ADDENDUM NO. 1

RE: RIVERSIDE HIGH-RISE MAILBOX REPLACEMENT
Elkhart Housing Authority
Elkhart, Indiana

DATE: November 3, 2025

FLOOR PLAN

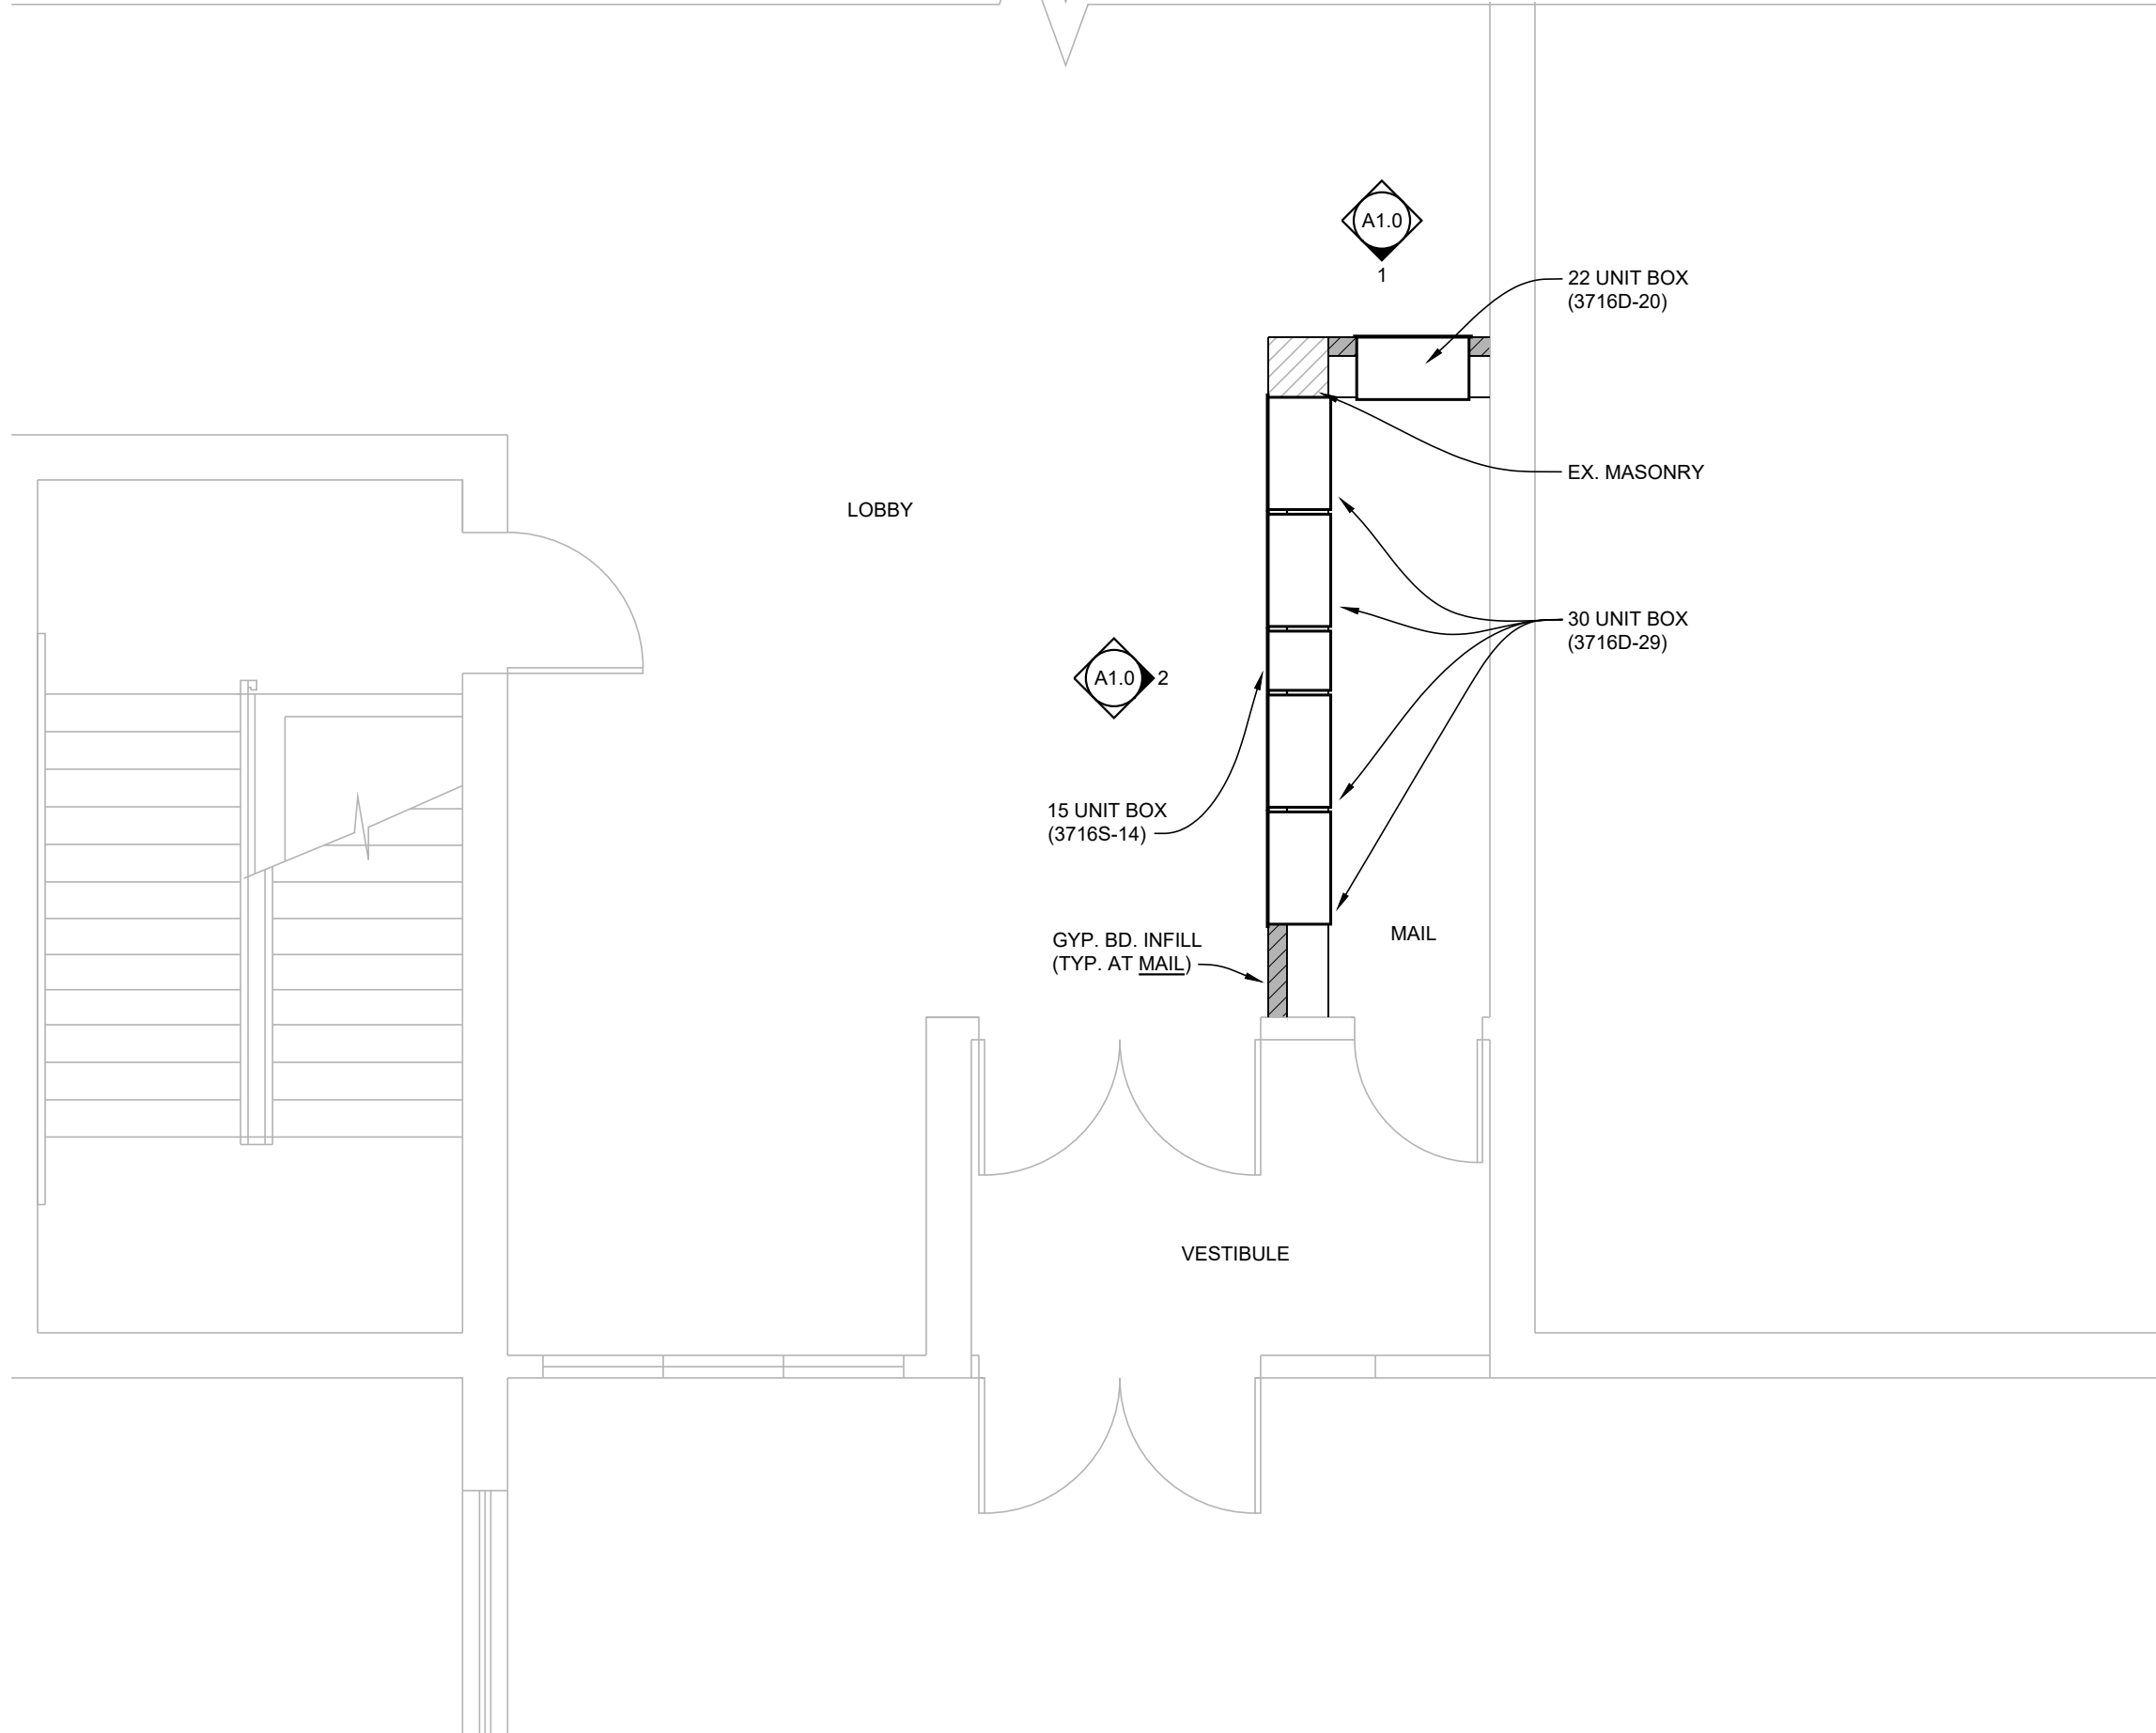
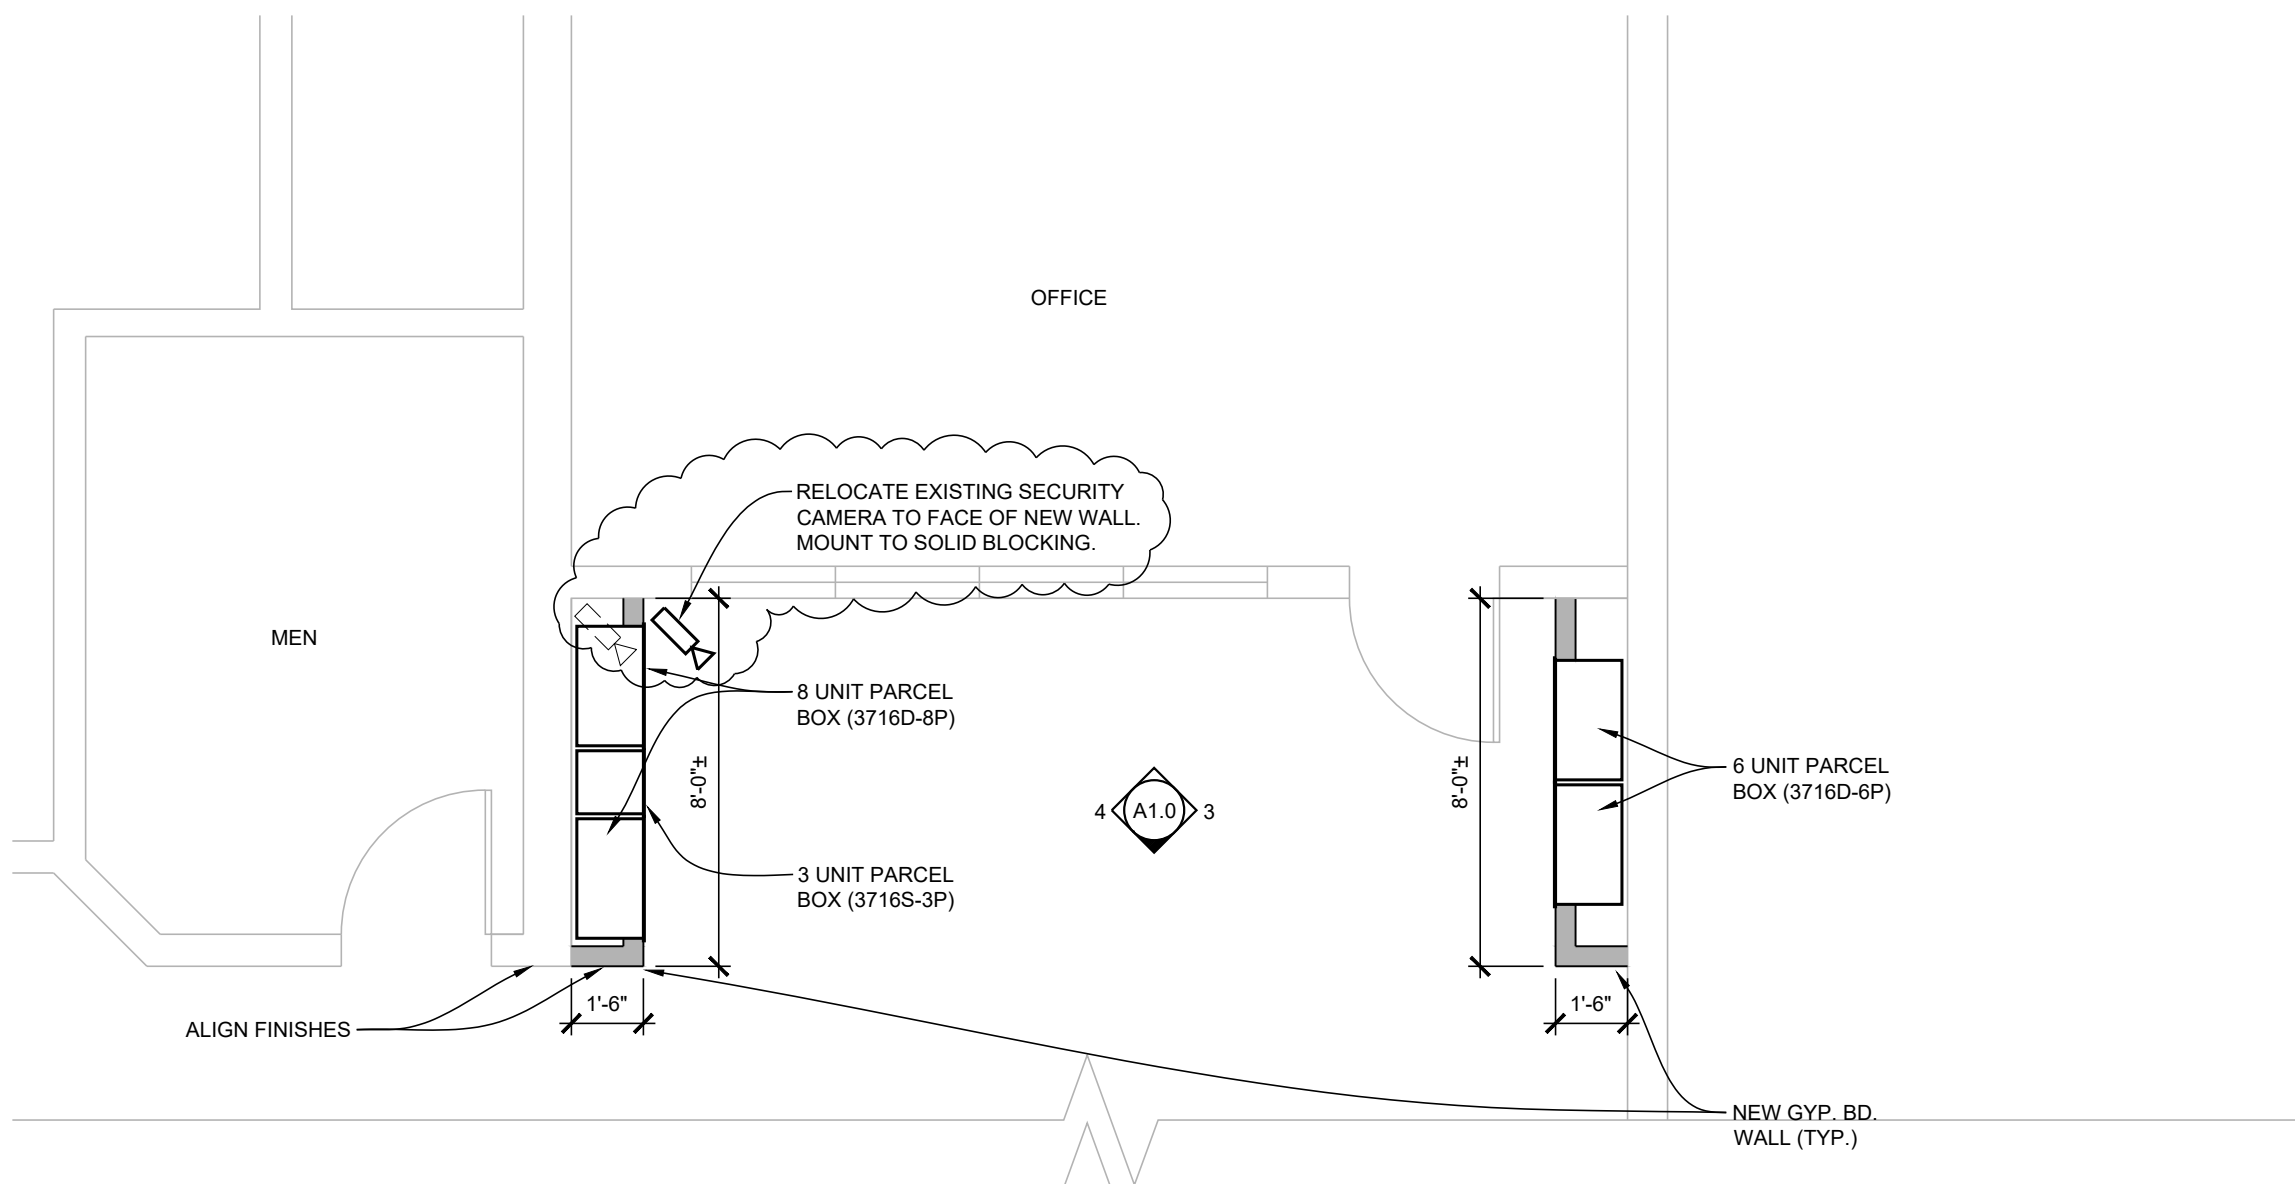
1. **DRAWINGS**; Sheet No. A1.0 (Revised and Reissued dated 10/27/2025):
 - a. FLOOR PLAN; is reissued.
 - b. WORK SCOPE; add Note 8 as follows:
 8. RELOCATE EXISTING ATM TO ALTERNATE LOCATION IN THE LOBBY,
AS DIRECTED BY THE OWNER.
 - c. PHOTO 3 and PHOTO 4 are added.

7. INSTALL BLOCKING AS REQUIRED TO SUPPORT NEW MAILBOXES.
8. RELOCATE EXISTING ATM TO ALTERNATIVE LOCATION IN THE LOBBY AS DIRECTED BY OWNER
